February 24, 2021
Project No. S168-182

San Bernardino County Department of Public Health Division of Environmental Health Services		EHS REF# _____
Percolation Report		
DESIGN RATE: 58 square feet per 100 gallons septic tank capacity		
This rate applies to:		
<input checked="" type="checkbox"/> Location(s) where tested	<input type="checkbox"/> Leach lines/bed	<input checked="" type="checkbox"/> Seepage pits
<input type="checkbox"/> Replacement only	<input type="checkbox"/> Entire lot/subdivision	<input type="checkbox"/> Limited to:
Additional requirements:		
<input type="checkbox"/> Maintain septic tank minimum _____ ft setback from _____		
<input type="checkbox"/> Maintain disposal area minimum _____ ft setback from _____		
<input type="checkbox"/> New construction requires perc test	<input type="checkbox"/> Clearance from _____	RWQCB
<input type="checkbox"/> EHS special conditions apply		
CONSTRUCTION DETAILS SUBJECT TO BUILDING AND SAFETY APPROVAL

Re: Revised Percolation Testing and On-Site Wastewater Treatment System (OWTS) Design
Proposed Rancho Yard Building
San Bernardino County Public Works Department:
12158 Baseline Road, Rancho Cucamonga, California
Assessor Parcel No. 1

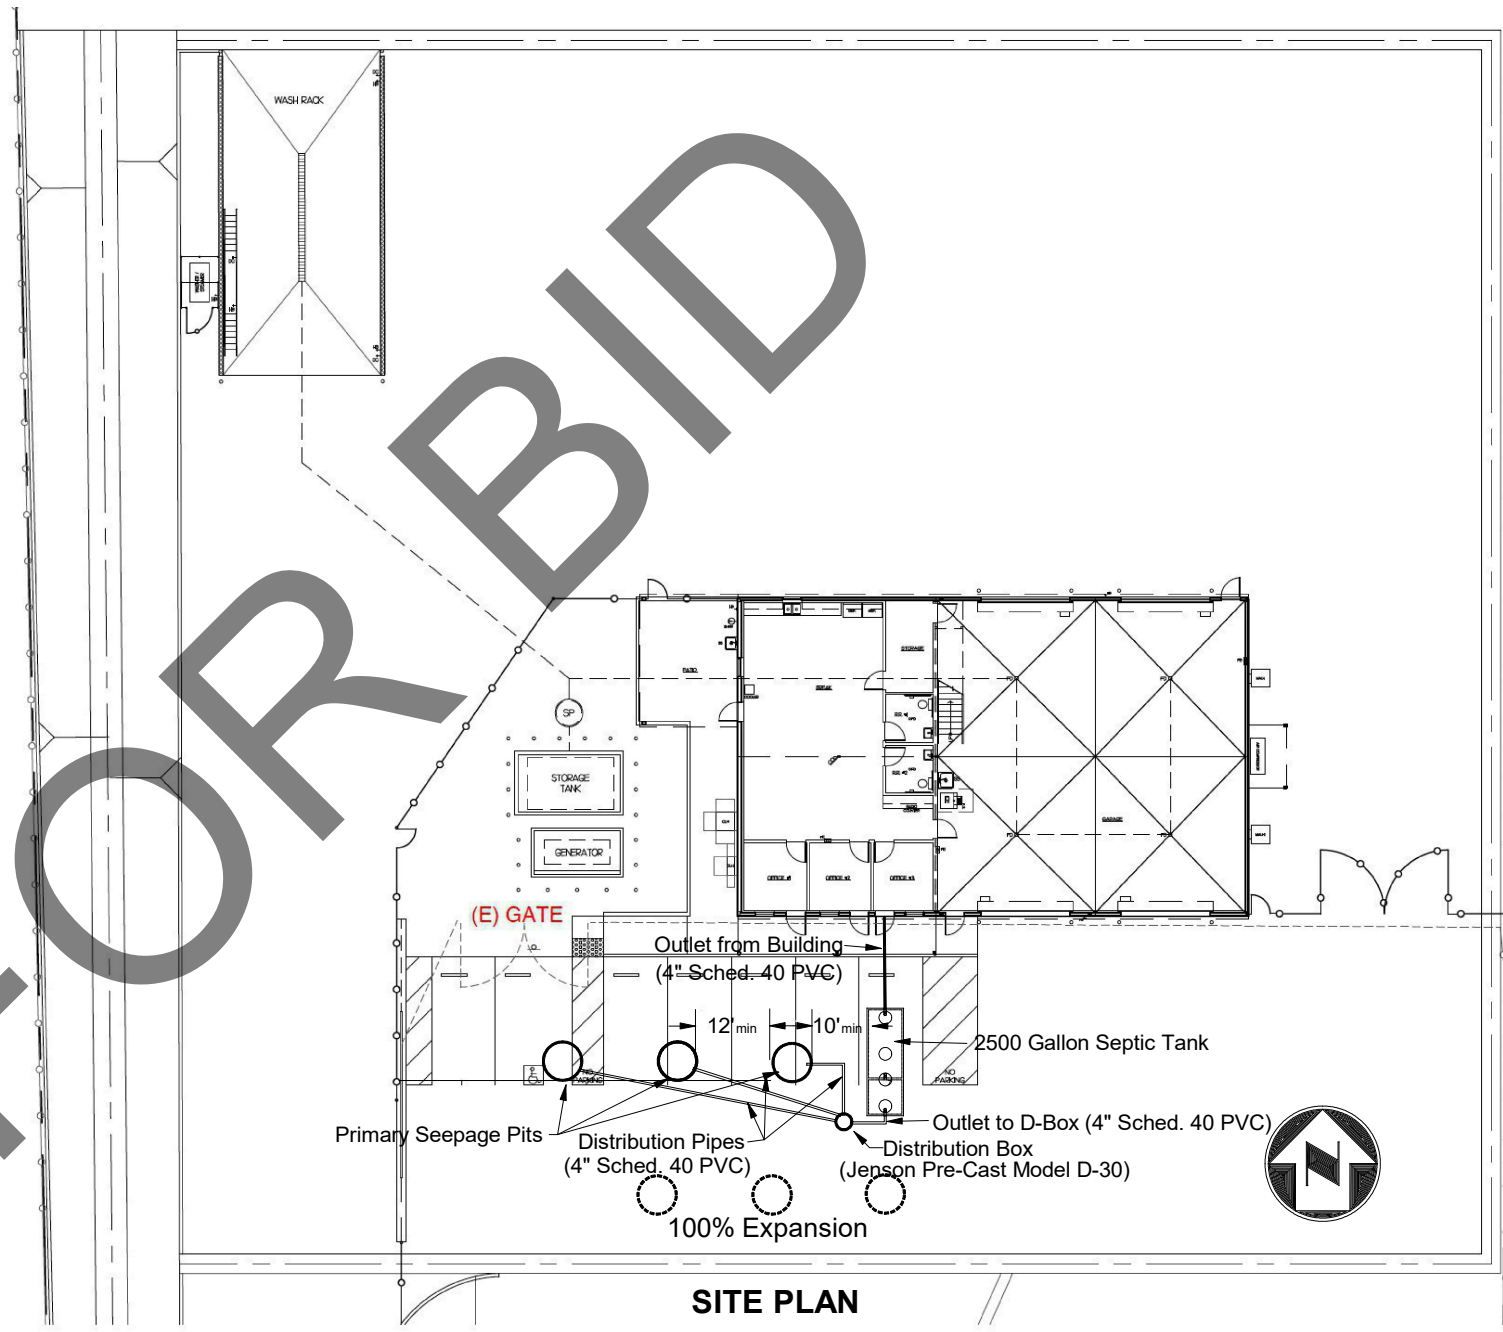
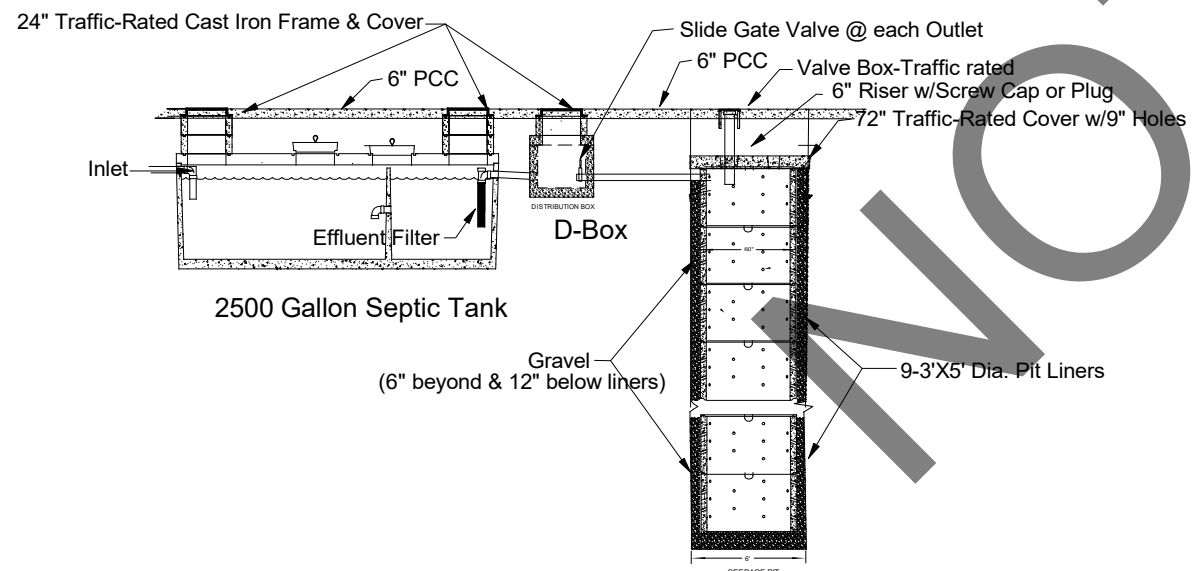
Inspector Comments: Provide occupancy information/calculations in estimated wastewater flow for the project according to the California Plumbing Code Table H 201.1(2)

Description: The septic tank size shall be based on the number of fixture units or the estimated daily flow based on the type of business, whichever is greater. Refer to 2013 CPC Table H 2.1 and H 2.1(1). Calculations for the fixture unit count and estimated daily flow shall be provided with the plot plan.

FIXTURE UNITS SEPTIC TANK CAPACITY (per Table H 201.1(1))
 Fixture Units (See Report): 28
 Minimum Septic Tank Capacity per Table H 201.1(1) = 1500 gallons
 FLOW RATE DETERMINATION (Table H 201.1(2))
 No. of Employees; 16
 Gals/Employee: 25
 Daily Flow = 25 gals/person X 16 people = 400 gals/day
 Minimum Septic Tank Capacity per Table H 201.1(2) = 400 gals. X 1.5 = 600 gallons
 DESIGN SEPTIC TANK CAPACITY: 2500 Gallons
 PERCOLATION RATE: 1.7 Gallons/Square Foot/Day
 NUMBER OF SEEPAGE PITS: 3
 SEEPAGE PIT DIAMETER: 6 Feet
 SEEPAGE PIT DEPTH: 27 Feet Below Inlet
